Subject: RE: Proposed Redevelopment at 819-827 Fort Street

I am writing to you in regards to the proposed Rezoning, Heritage Alteration Permit & Heritage Designation application at 819-827 Fort Street, that will be reviewed at Committee of the Whole this Thursday, January 24th (item E2 on the Agenda under 'Land Use Matters'). As we do not have an opportunity to make a formal presentation to the Committee, I would like to take this time to provide some background on the application for your reference.

1 A303 **EAST ELEVATION**

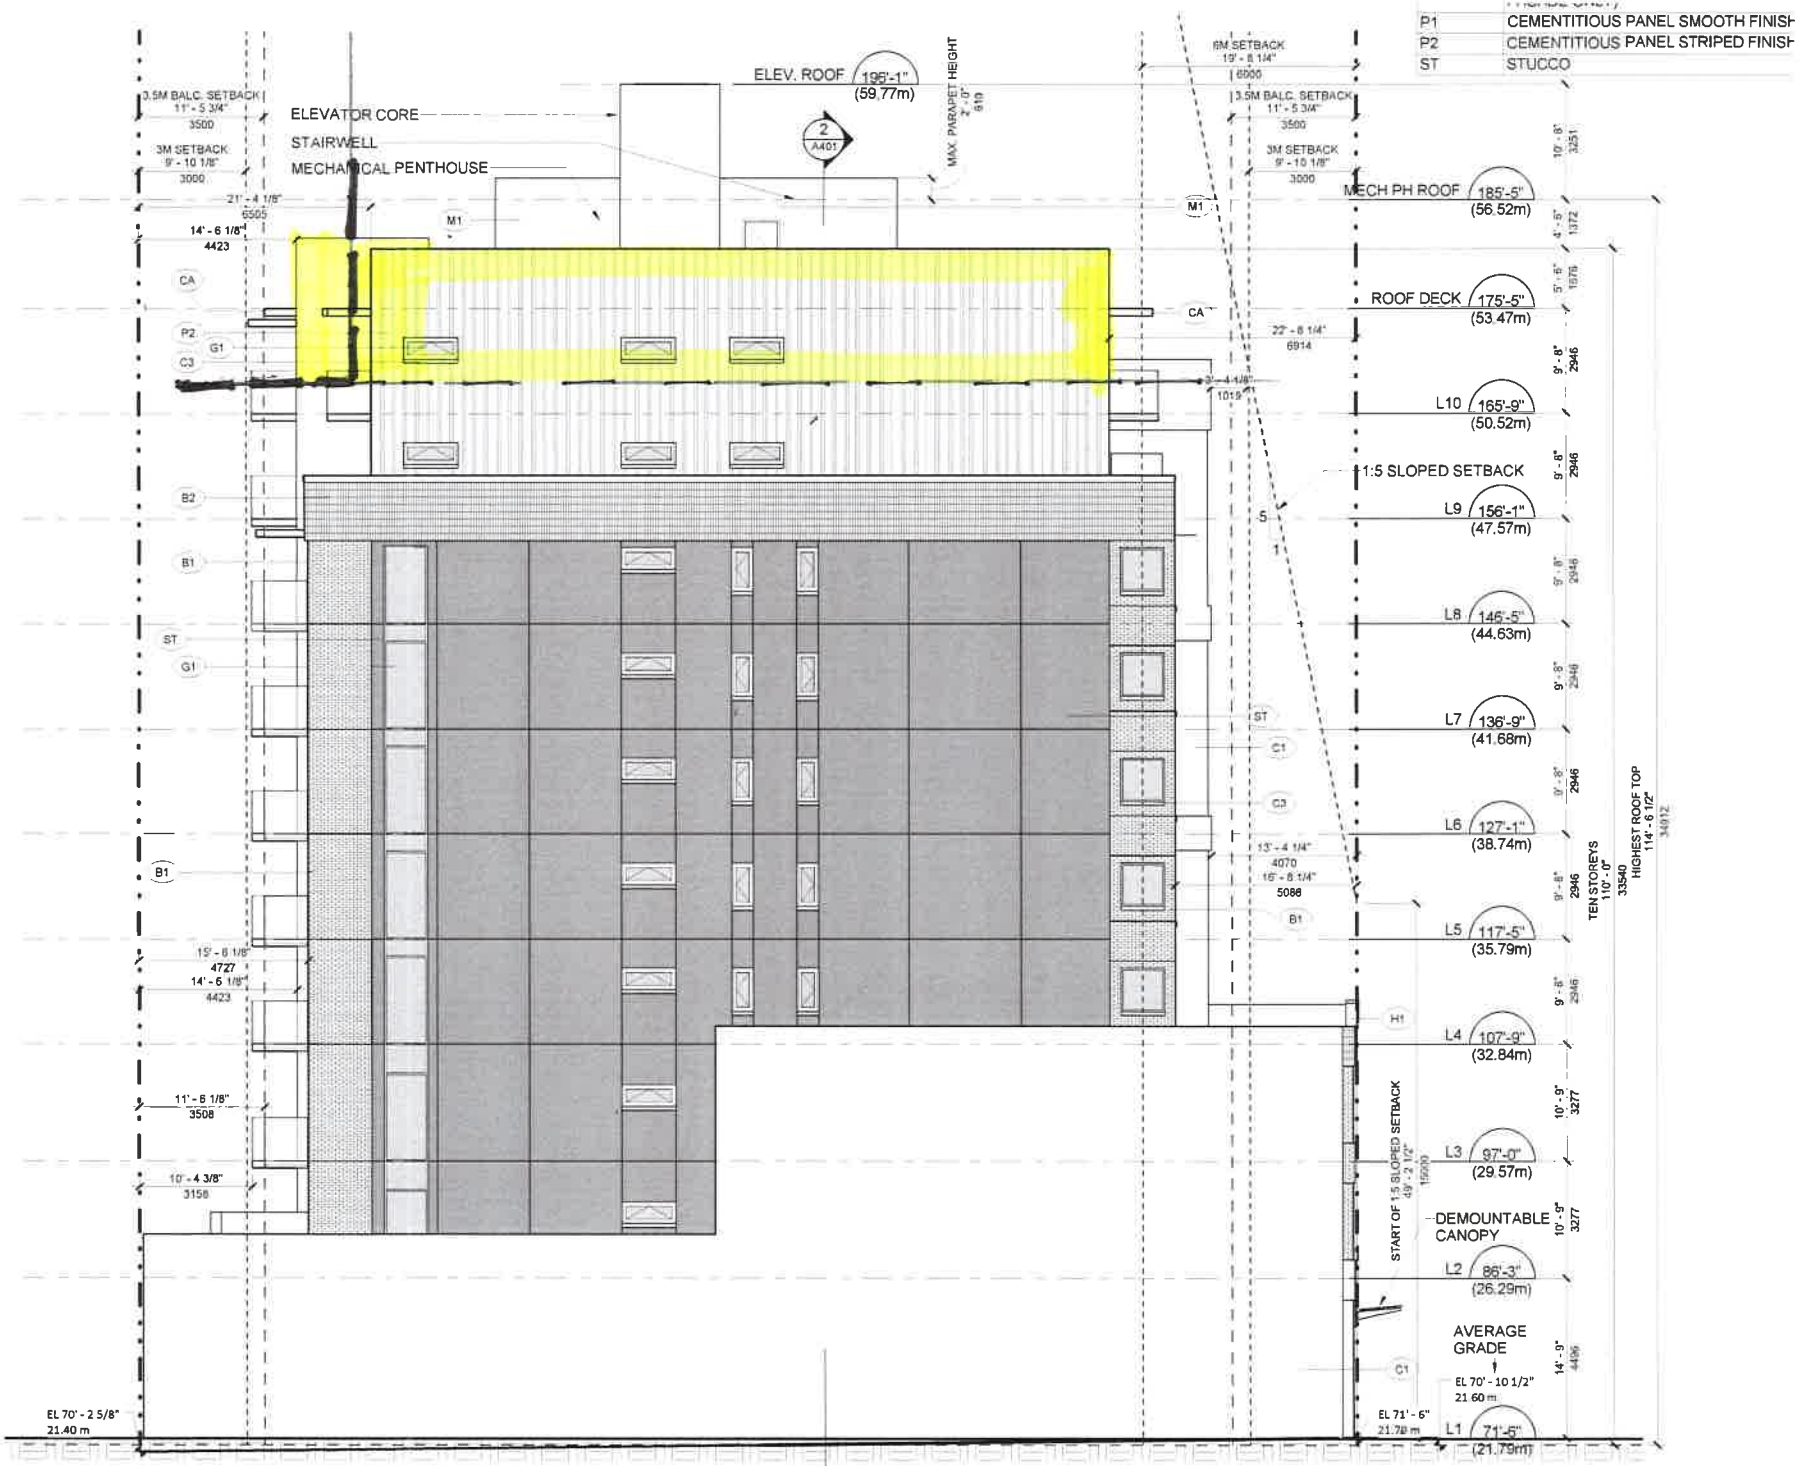
We note that Staff are recommending a further step back at the top floor, for the portion of the building above 30.0m at the side and rear elevations. For clarity, this is a setback that will only affect the 10th floor, for portions above the 30m height guideline.

Please find attached a mark-up of the existing elevation for your reference.

This guideline in the DCAP is intended to reduce space between taller towers with more than 10-storeys and up to 45m. The additional height of this project that is over the 30m guideline is a direct result of retaining the historic building facades 819 and 825 Fort, which has higher floor to ceiling heights than a new residential building. Therefore the entire project is pushed 'upwards' requiring more height overall for a 10-storey building, above the 30m. This results in the overall height increase of entire building where only a <u>portion</u> of the top floor exceeds 30m.

Most importantly, the setting back of the 10th floor, even though only a portion of it exceeds 30m, reduces the number of rental units by 2 2-bedroom homes.
